1. TCP Phase 1, Utility Work

DESIGNED	13 FEB 2017	PERMIT SUBMISSION REVISIONS		
DRAWN	30 NOV 2016	PERMIT SUBMISSION		
CHECKED	REVISION	DATE	DESCRIPTION	BY
CERTIFICATION	TRAFFIC CONTROL PLAN - PHASE IIB			APP.
WARD 8 SHORT TERM FAMILY HOUSING 4225 8TH STREET, S.E. WASHINGTON DC, 20032			DRAWING NO.	
 SORG ARCHITECTS 919 U ST. NW WASHINGTON DC 20001 T: 202.303.6445 F: 202.303.6407			CIV6.1B 	
REGISTRATION NO. PE007874 EXPIRES: 03/31/2018	GOVERNMENT OF THE DISTRICT OF COLUMBIA			PROJECT NO. 55-1616-00
DEPARTMENT OF GENERAL SERVICES			BLDG NO.	
			DATE	
			SHEET OF	
<div>1/4"=1'-0" 3/16"=1'-0" 1/8"=1'-0" 3/32"=1'-0" 1/16"=1'-0" 1/16"=1'-0"</div> <div></div>

DESIGNED		3 FEB 2017	PERMIT SUBMISSION REVISIONS		
DRAWN		30 NOV 2016	PERMIT SUBMISSION		
CHECKED	REVISION	DATE	DESCRIPTION	BY	APP.
CERTIFICATION		TRAFFIC CONTROL PLAN - PHASE III			
		WARD 8 SHORT TERM FAMILY HOUSING 4225 6TH STREET, S.E. WASHINGTON DC, 20032			DRAWING NO. CIV6.2
		 SORG ARCHITECTS 218 U ST. NW WASHINGTON DC 20001 T: 202.383.8445 F: 202.383.5497			
REGISTRATION NO. PE007614 EXPIRES 03/02/18		GOVERNMENT OF THE DISTRICT OF COLUMBIA DEPARTMENT OF GENERAL SERVICES			PROJECT NO. GS-161-6-00 BLDG NO. DATE
					SHEET OF

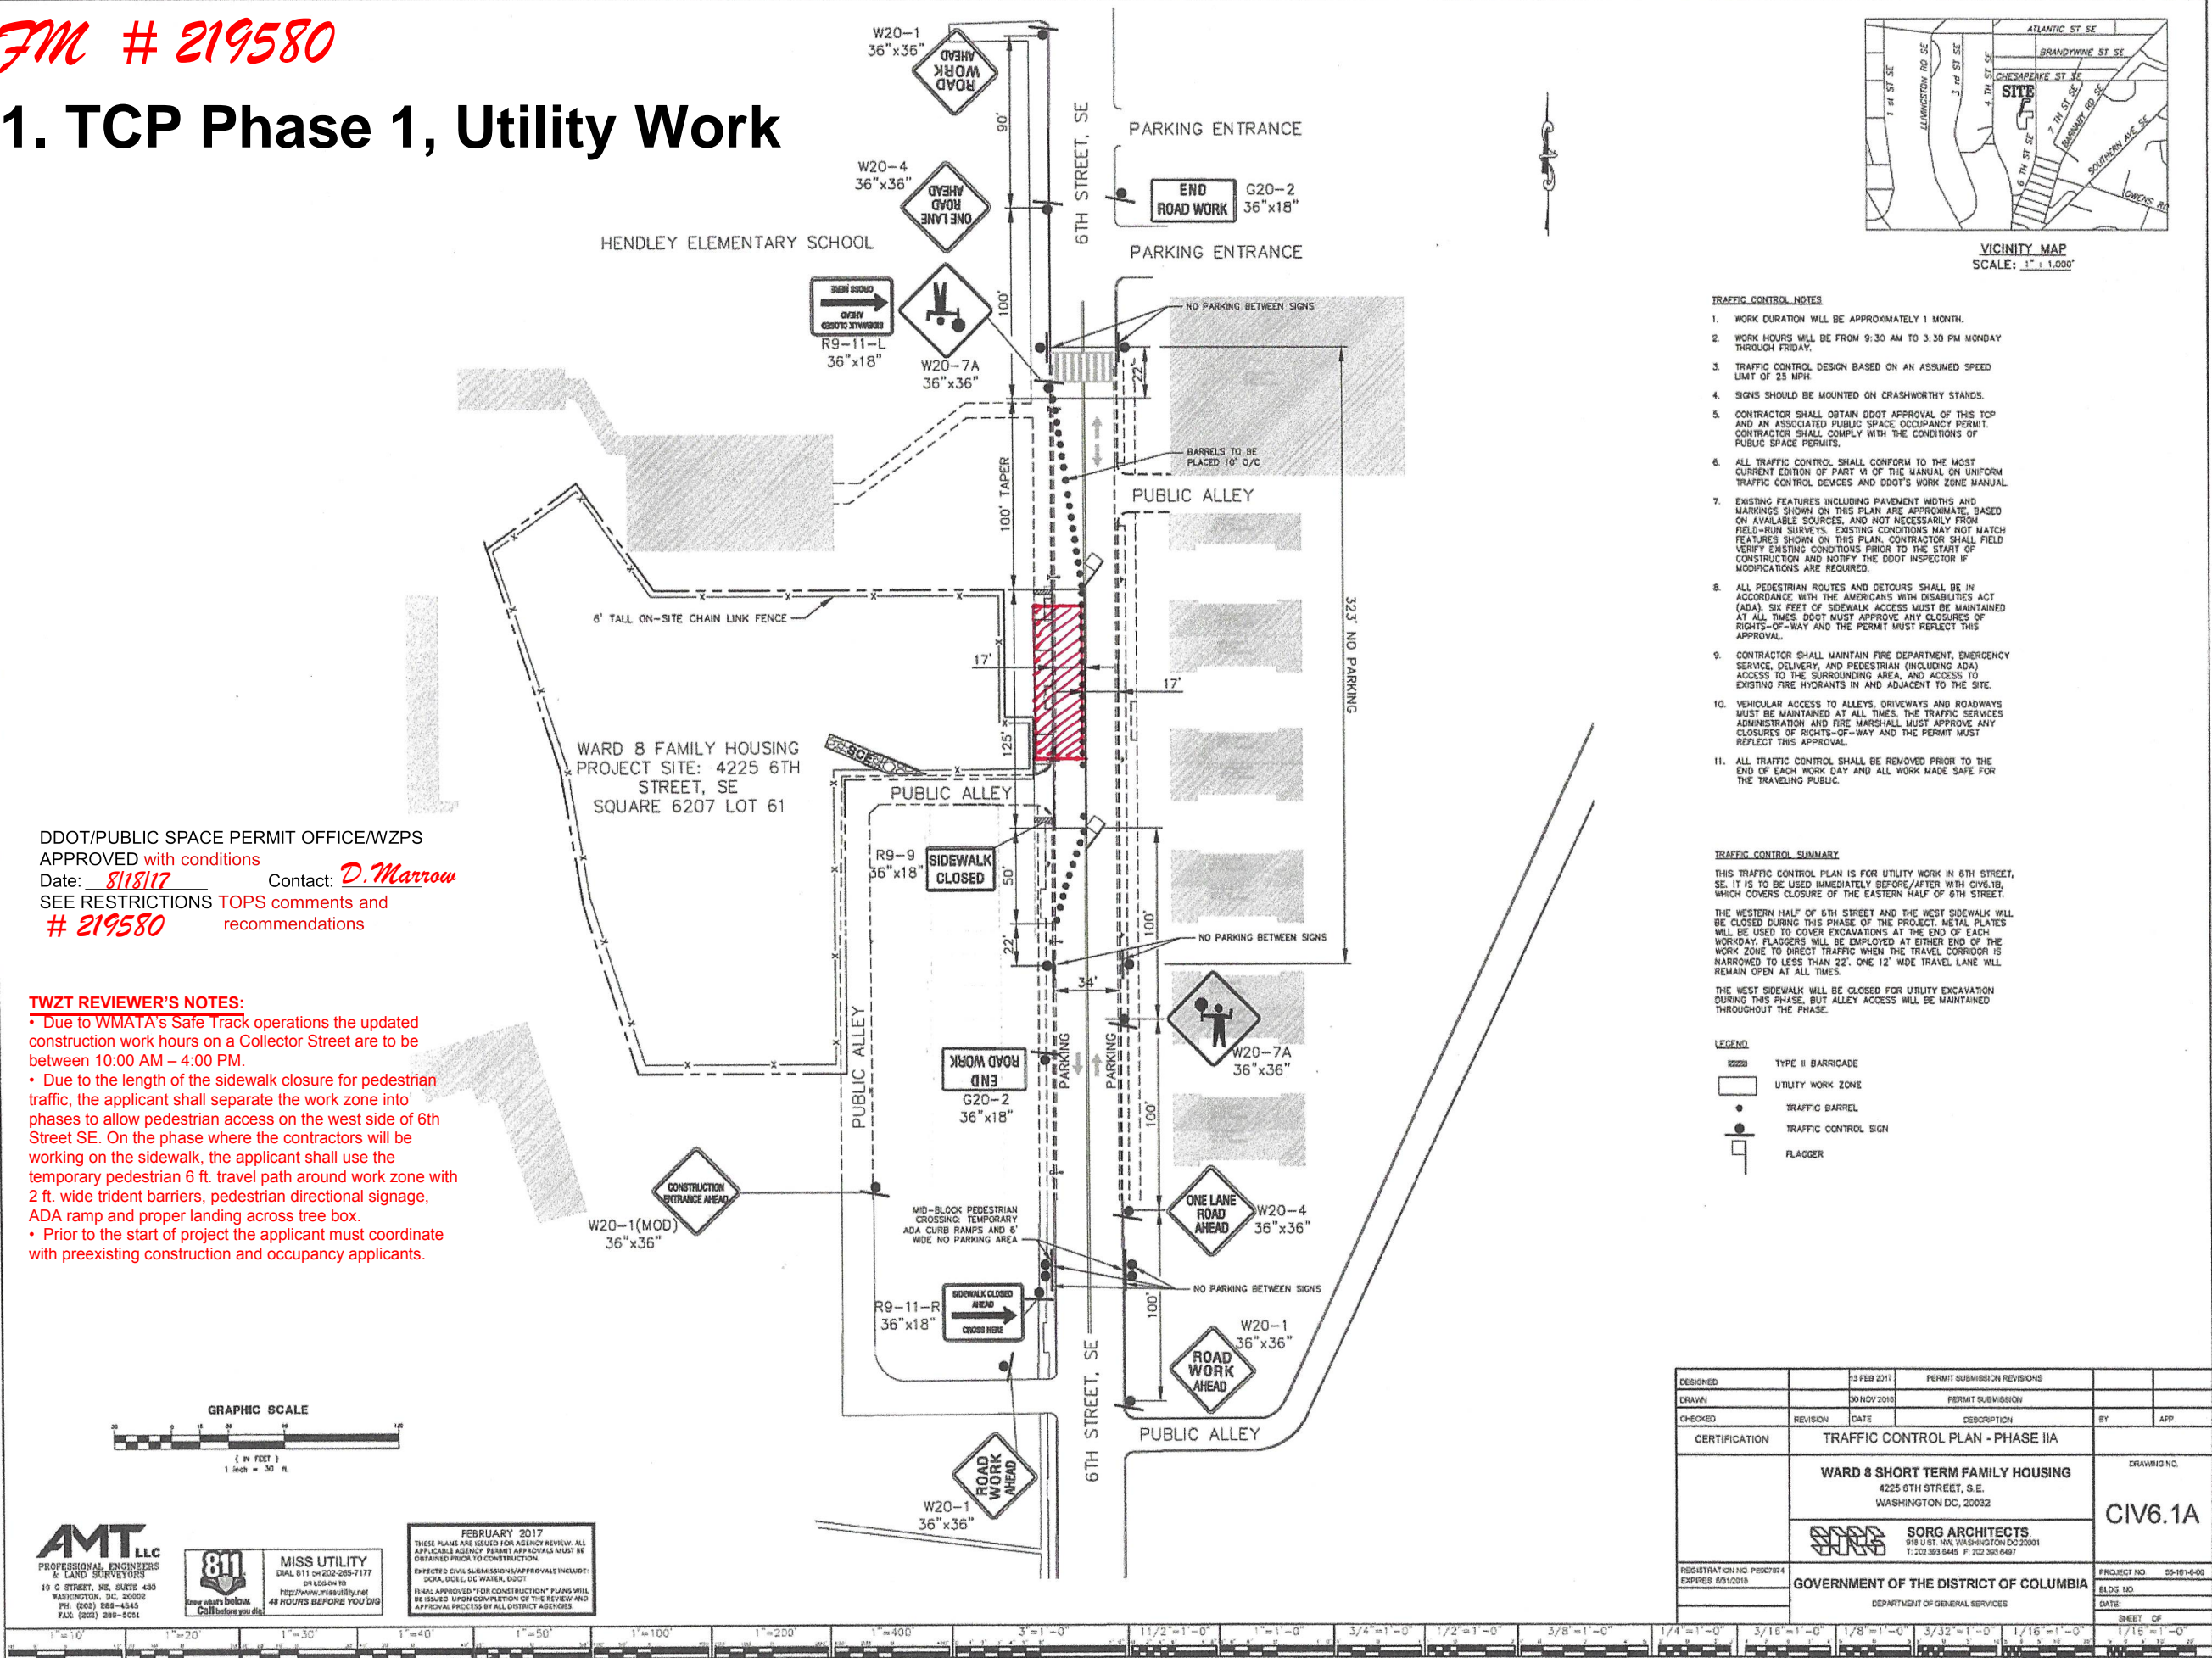
DDOT/PUBLIC SPACE PERMIT OFFICE/WZPS
APPROVED with conditions
Date: 8/18/17 Contact: D. Marrow
SEE RESTRICTIONS TOPS comments and
219580 recommendations

- Due to WMATA's Safe Track operations the updated construction work hours on a Collector Street are to be between 10:00 AM – 4:00 PM.
- Due to the length of the sidewalk closure for pedestrian traffic, the applicant shall separate the work zone into phases to allow pedestrian access on the west side of 6th Street SE. On the phase where the contractors will be working on the sidewalk, the applicant shall use the temporary pedestrian 6 ft. travel path around work zone with 2 ft. wide trident barriers, pedestrian directional signage, ADA ramp and proper landing across tree box.
- Prior to the start of project the applicant must coordinate with preexisting construction and occupancy applicants.

3. TCP Phase 1, Alley Widening

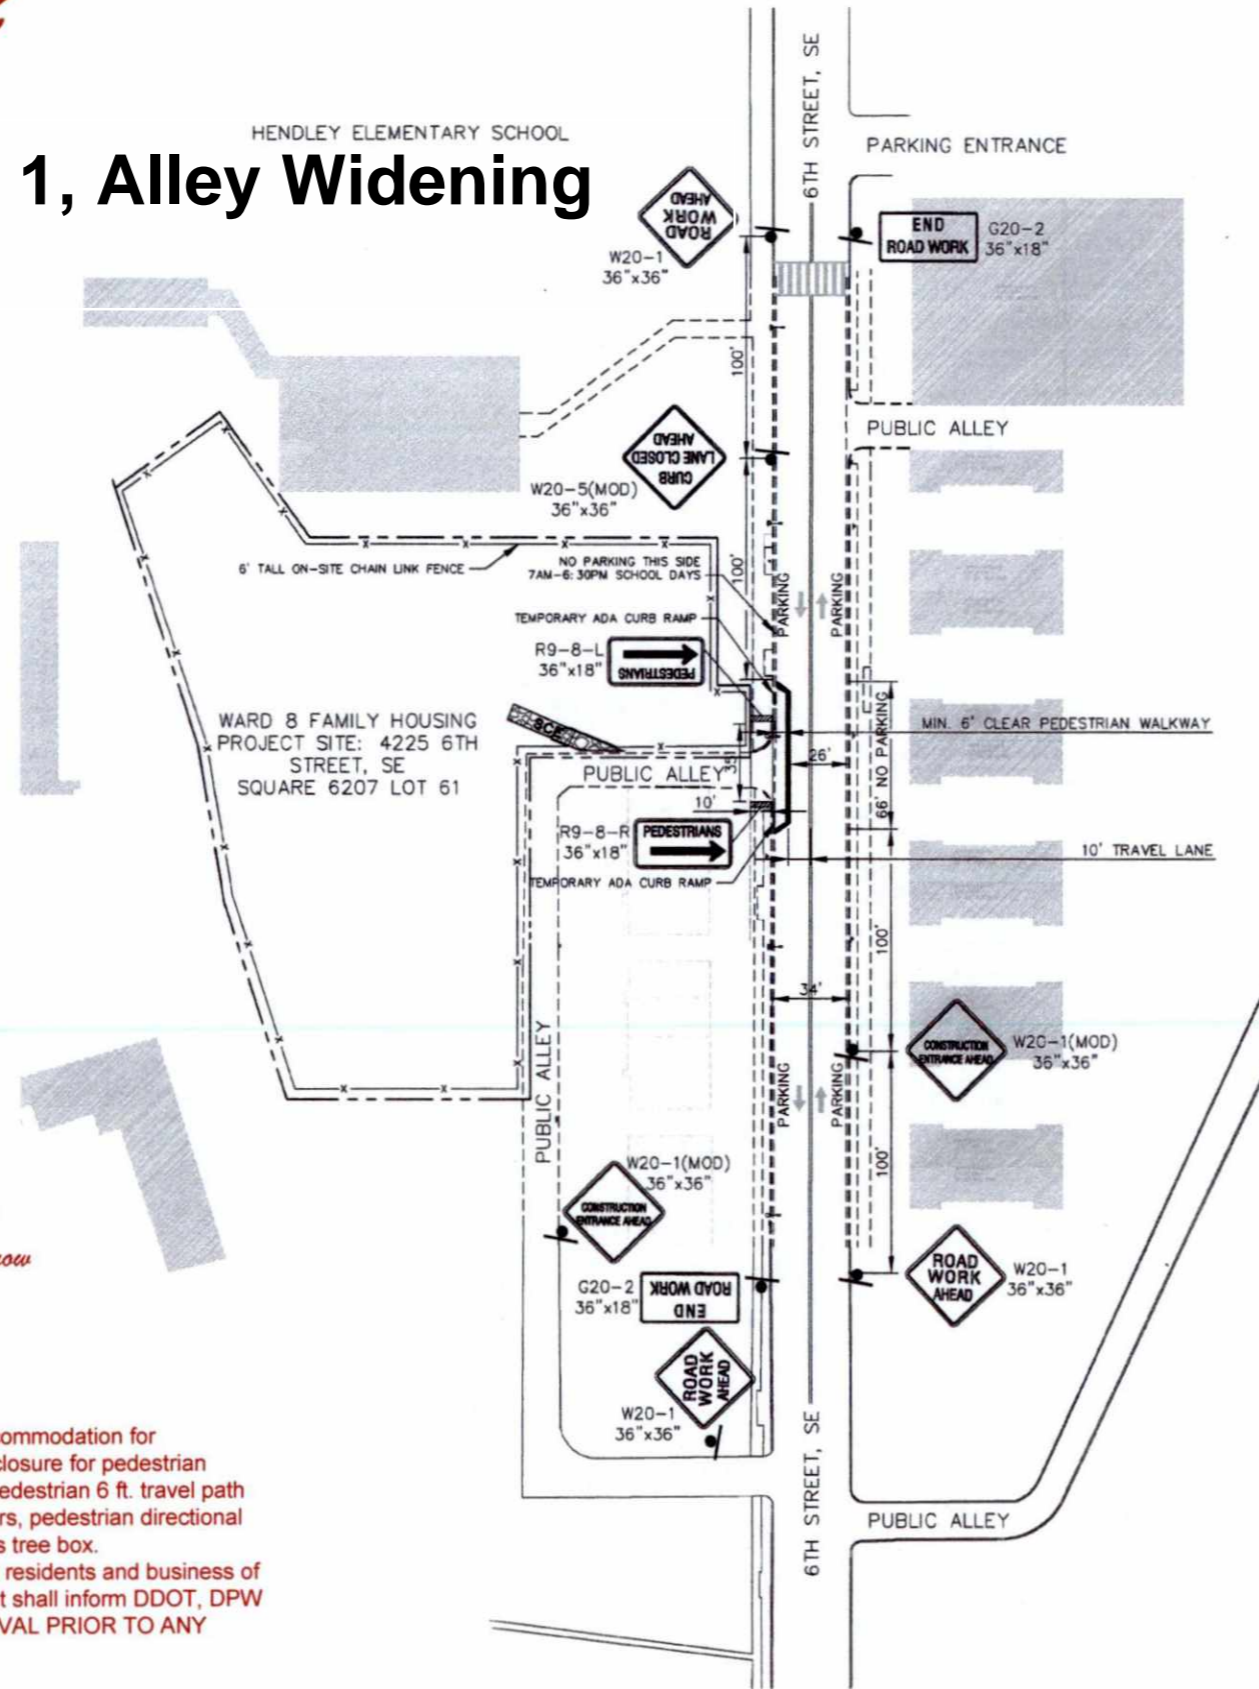
DDOT/PUBLIC SPACE PERMIT OFFICE/WZPS
APPROVED with conditions
Date: 9/15/17 Contact: D. Marrow
SEE RESTRICTIONS TOPS comments and recommendations
219832

- On phase CIV6.2, according to the safe accommodation for pedestrian, due to the length of the sidewalk closure for pedestrian traffic, the applicant shall use the temporary pedestrian 6 ft. travel path around work zone with 2 ft. wide trident barriers, pedestrian directional signage, ADA ramp and proper landing across tree box.
- On phase CIV6.3, the applicant shall inform residents and business of intent of alley closure. In addition the applicant shall inform DDOT, DPW and "MUST HAVE FIRE MARSHALL APPROVAL PRIOR TO ANY ROAD OR ALLEY CLOSURE".

4. TCP Phase 2, Alley Widening

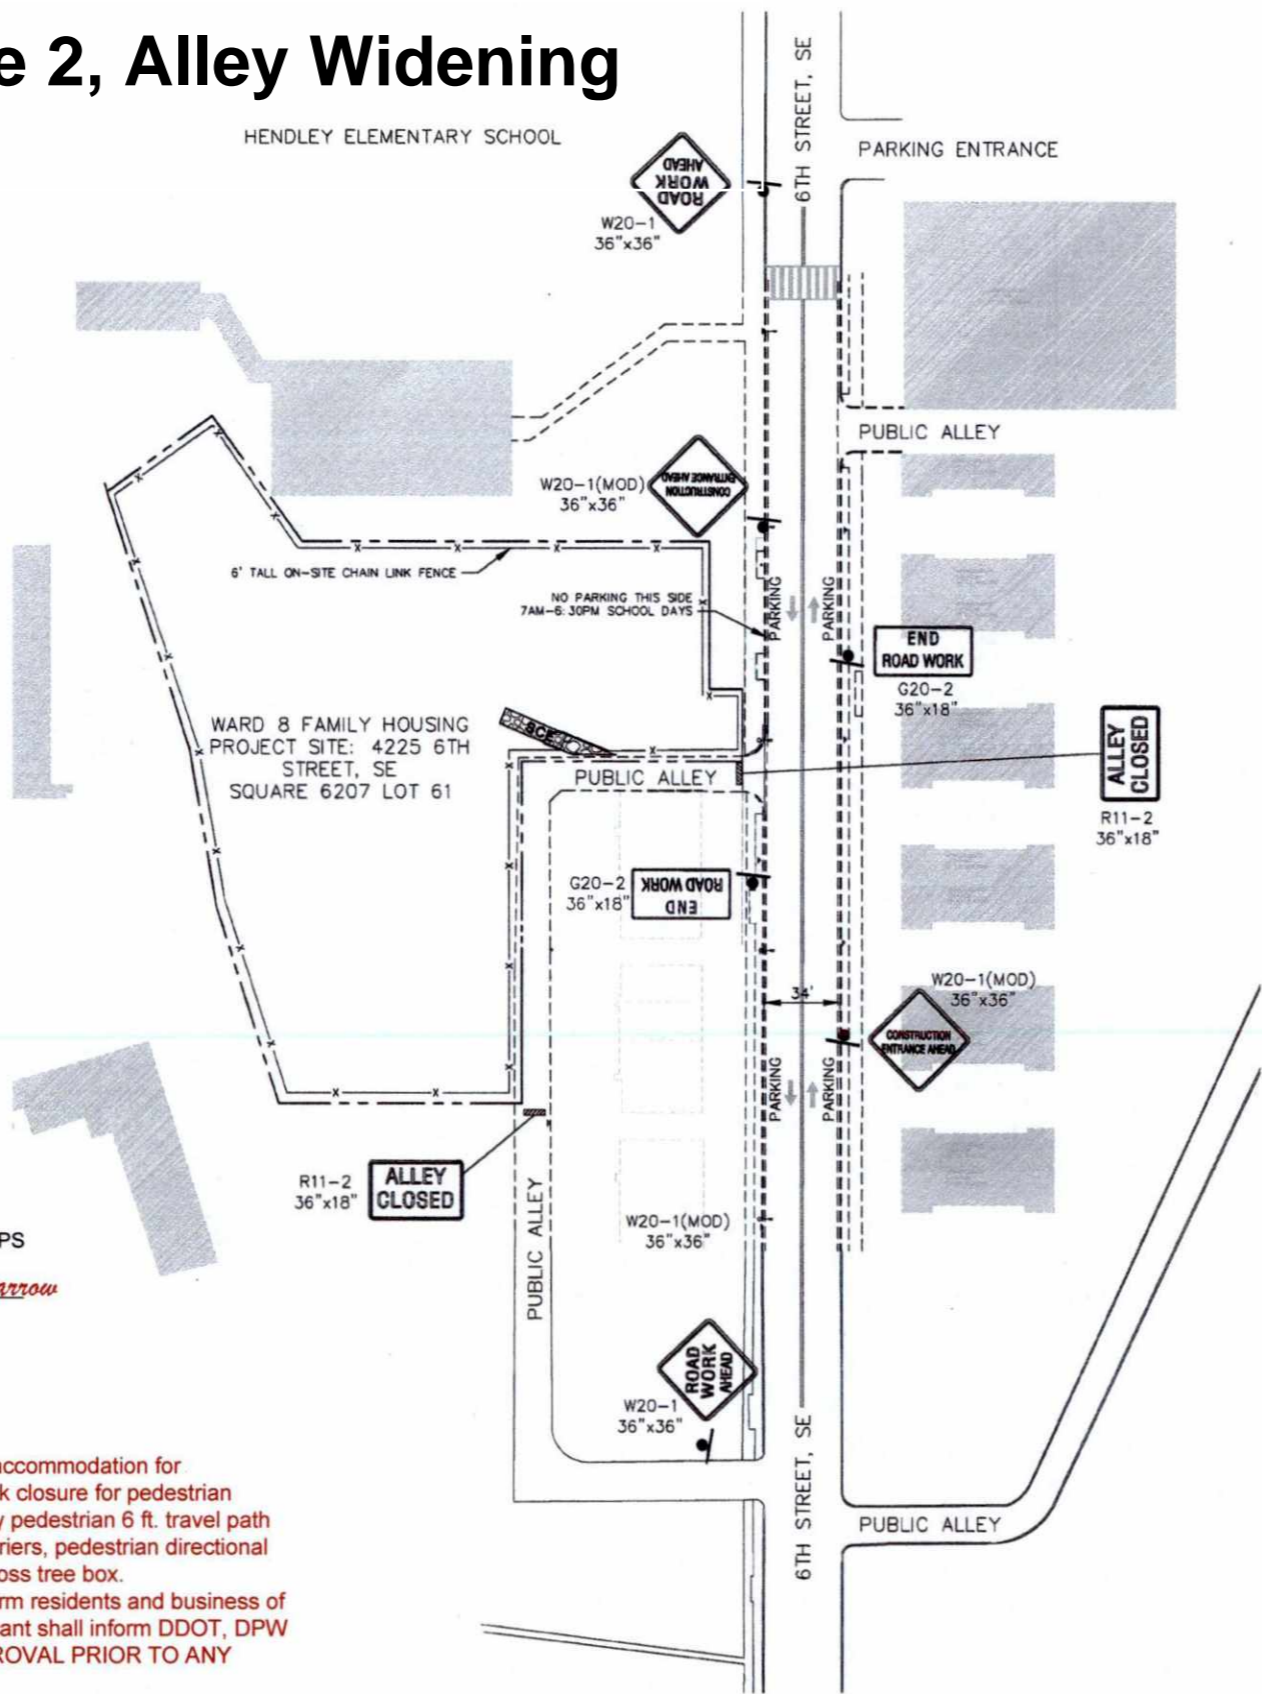
DDOT/PUBLIC SPACE PERMIT OFFICE/WZPS
APPROVED with conditions
Date: 9/15/17 Contact: D. Marrow
SEE RESTRICTIONS TOPS comments and recommendations
219832

- TWZT REVIEWER'S NOTES:**
- On phase CIV6.2, according to the safe accommodation for pedestrian, due to the length of the sidewalk closure for pedestrian traffic, the applicant shall use the temporary pedestrian 6 ft. travel path around work zone with 2 ft. wide trident barriers, pedestrian directional signage, ADA ramp and proper landing across tree box.
 - On phase CIV6.3, the applicant shall inform residents and business of intent of alley closure. In addition the applicant shall inform DDOT, DPW and "MUST HAVE FIRE MARSHALL APPROVAL PRIOR TO ANY ROAD OR ALLEY CLOSURE".
